Priddy Property: Preliminary Plan No. 120170160

Priddy Property Preliminary Plan No. 120170160:
Request to subdivide the Subject Property into eight (8) lots for 8 detached single family houses and one (1) outlot, located at 13511 Query Mill Road; 26.925 acres, RE-2; 2002 Potomac Subregion Master Plan.
Recommendation – Approval with conditions

PRELIMINARY PLAN NO. 120170160: Staff recommends approval of the Preliminary Plan subject to the following conditions:

Figure 5 – Variance Tree Distribution

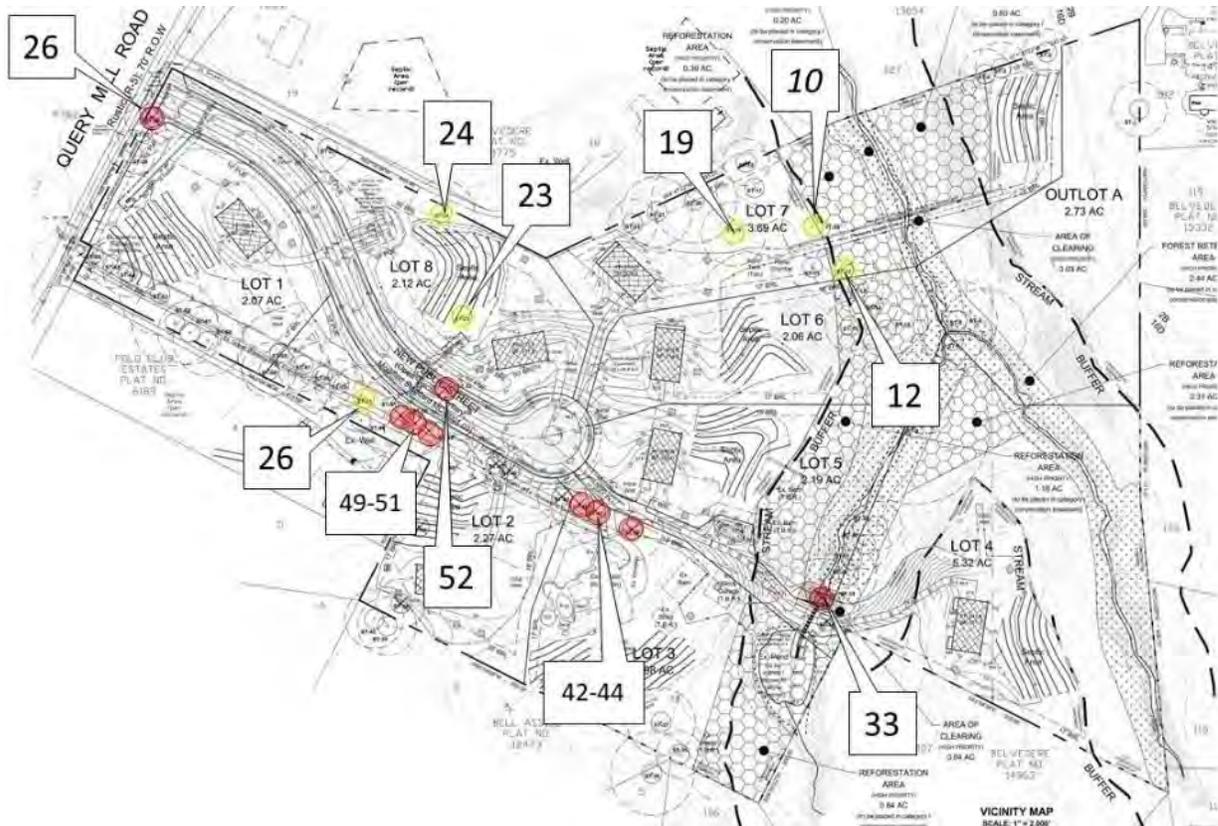
Staff has determined that impacts to variance trees for the development of this Property are unavoidable and the Property could not be reasonably developed without a Variance Request.

As a result, an unwarranted hardship would be created if a variance were not considered. Therefore, Staff concurs that the Applicant has a sufficient unwarranted hardship to justify a variance request.

There are 9 trees proposed for removal in this variance request resulting in a total of 285.0 inches of DBH being removed. For removal of specimen trees associated with a variance request, Staff recommends mitigation for the tree loss by replacing the total number of DBH removed with $\frac{1}{4}$ of the amount of inches replanted. This results in a total mitigation of 71.25 inches of replanted trees. In this case, Staff recommends the Variance Tree mitigation plantings be done onsite within unforested areas of the SVB. If the planting is in accordance with afforestation planting guidelines Staff recommends the caliper inch be reduced to one-inch and planted at a density of 100 trees per acre. Final location and sizes will be determined at the time of the Final FCP

PRELIMINARY FOREST CONSERVATION PLAN
PRIDDY PROPERTY
Lot 3 of Polo Club Estates & P905, P899
Montgomery County, Maryland

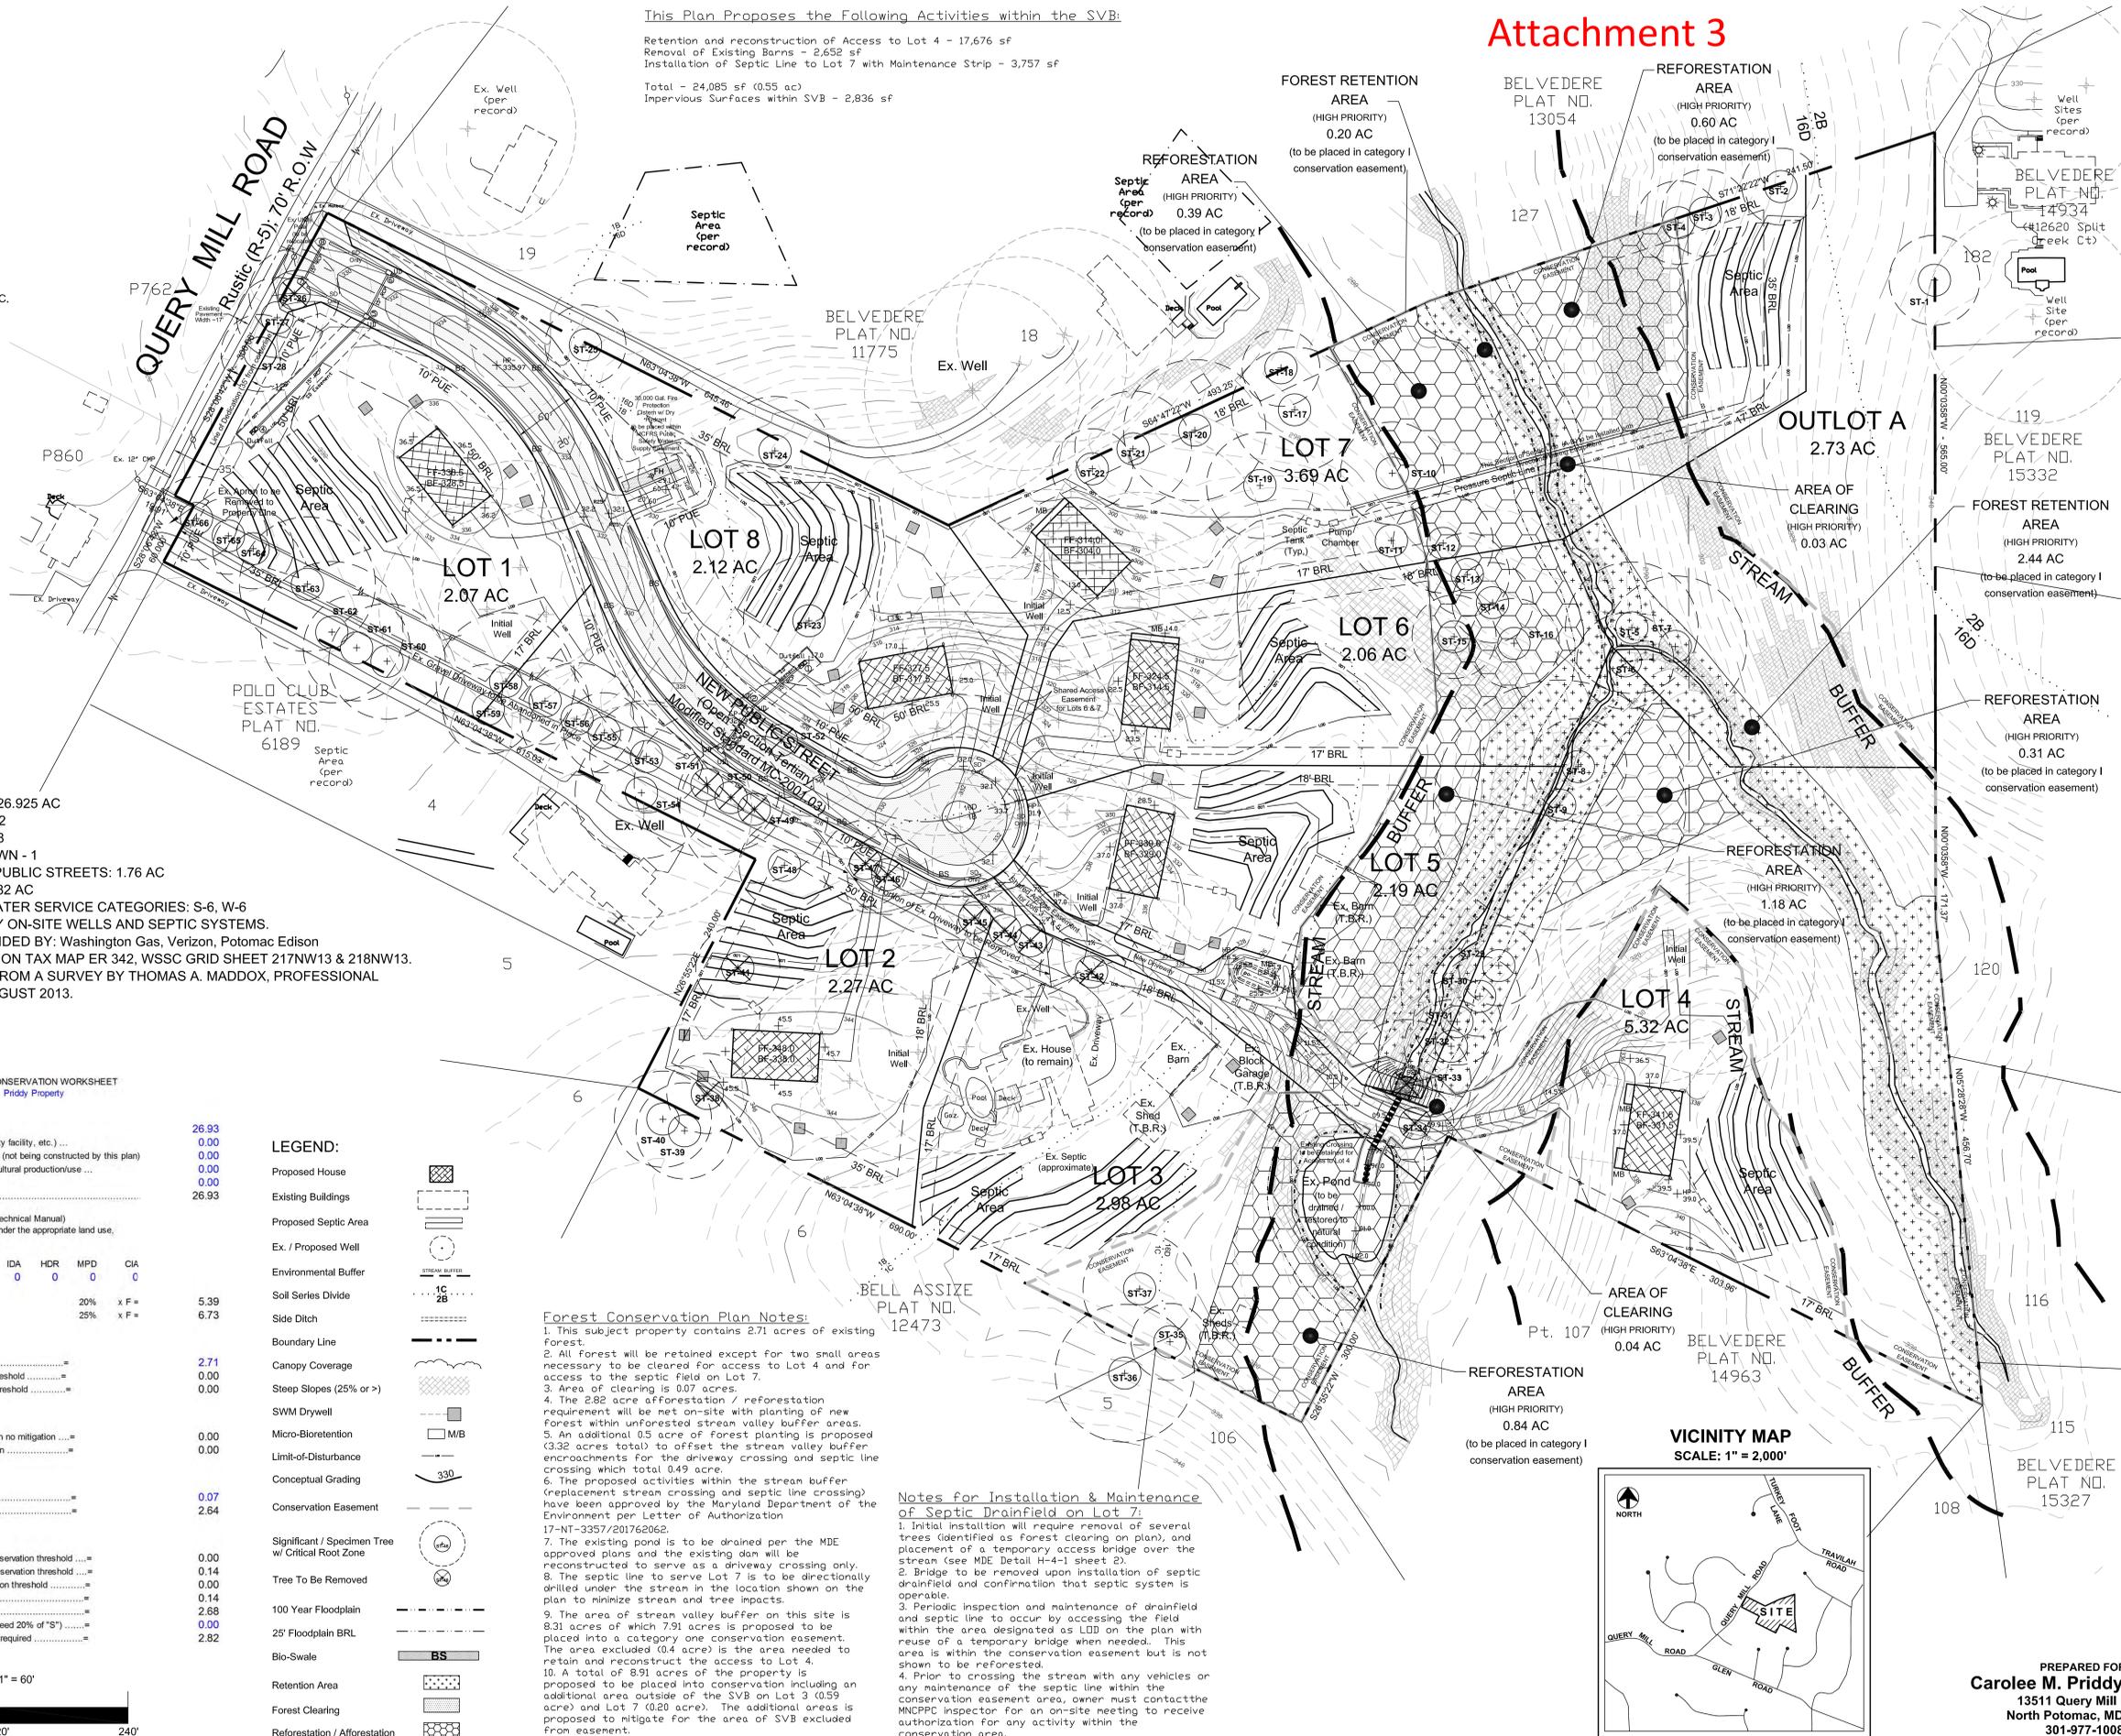
This Plan Proposes the Following Activities within the SVB:

- Retention and reconstruction of Access to Lot 4 - 17,676 sf
- Removal of Existing Barns - 2,652 sf
- Installation of Septic Line to Lot 7 with Maintenance Strip - 3,757 sf
- Total - 24,085 sf (0.55 ac)
- Impervious Surfaces within SVB - 2,936 sf

1. This subject property contains 2.71 acres of existing forest.
2. All forest will be retained except for two small areas necessary to be cleared for access to Lot 4 and for access to the septic field on Lot 7.

3. Area of clearing is 0.07 acres.
4. The 2.82 acre afforestation / reforestation requirement will be met on-site with planting of new forest within unafforested stream valley buffer areas.

5. An additional 0.5 acre of forest planting is proposed (3.32 acres total) to offset the stream valley buffer encroachments for the driveway crossing and septic line crossing which total 0.49 acre.

7. The existing pond is to be drained per the MDE approved plans and the existing dam will be reconstructed to serve as a driveway crossing only.
8. The septic line to serve Lot 7 is to be directionally drilled under the stream in the location shown on the plan to minimize stream and tree impacts.
